CT7-2E TEMPORARY REVISION - 05-0017

MM 05-11-03, SERVICE LIFE LIMITS 004

GAS GENERATOR TURBINE ROTOR PARTS - SERVICE LIFE LIMITS

Figure 1 Gas Generator Turbine Rotor Parts (Typical) - Service Life Limits

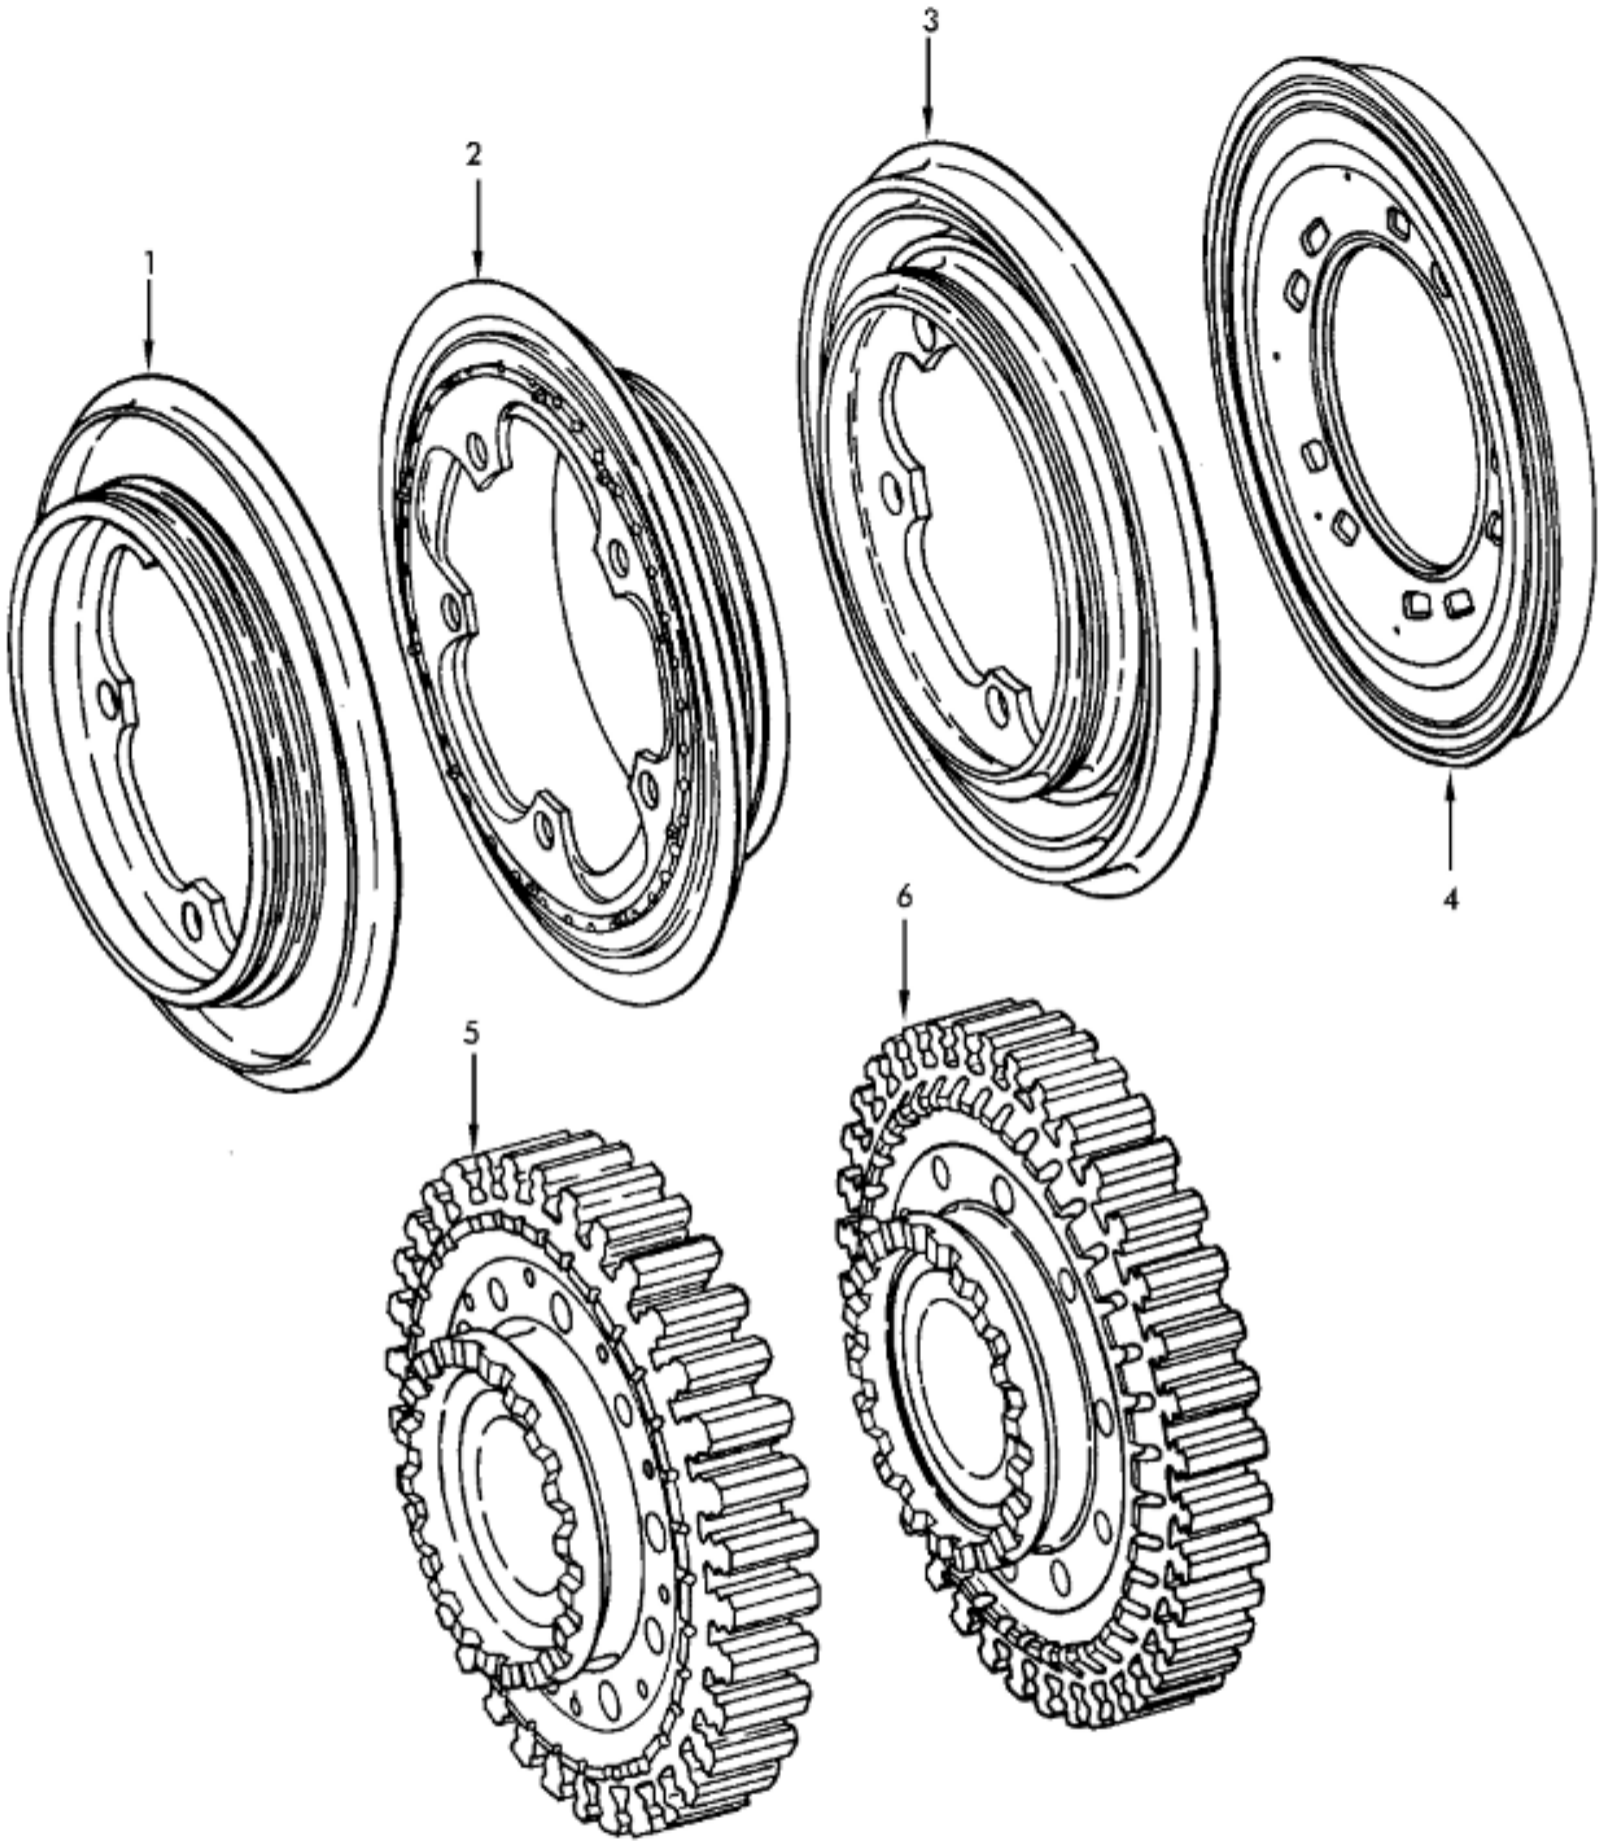
SUBJECT: GAS GENERATOR TURBINE ROTOR PARTS - SERVICE LIFE LIMITS
REASON: This Temporary Revision (TR) adds the data from TR 05-0017 which changes the Life Limits for Stage 2 Turbine Aft Cooling Plate PN 5166T27P01.
FILING INSTRUCTIONS: Put this TR in the CT7-2E Maintenance Manual, GEK 112043-02, replacing 05-11-03, SERVICE LIFE LIMITS 004, dated May 31/2017. Record this TR in the Record of Temporary Revisions. Update your media via the GE Aviation Web portal.

Figure Item Number	Nomenclature	Part Number	Life Limits (Cycles Since New)
1	Stage 1 Turbine Forward Cooling Plate	4185T23P01	7,500
2	Stage 1 Turbine Aft Cooling Plate	4185T24P01	7,500
3	Stage 2 Turbine Forward Cooling Plate	4106T80P03	7,500
4	Stage 2 Turbine Aft Cooling Plate	5166T27P01	3,100
5	Stage 1 Turbine Disk	4185T13P01	7,500
6	Stage 2 Turbine Disk	4185T14P01	6,800
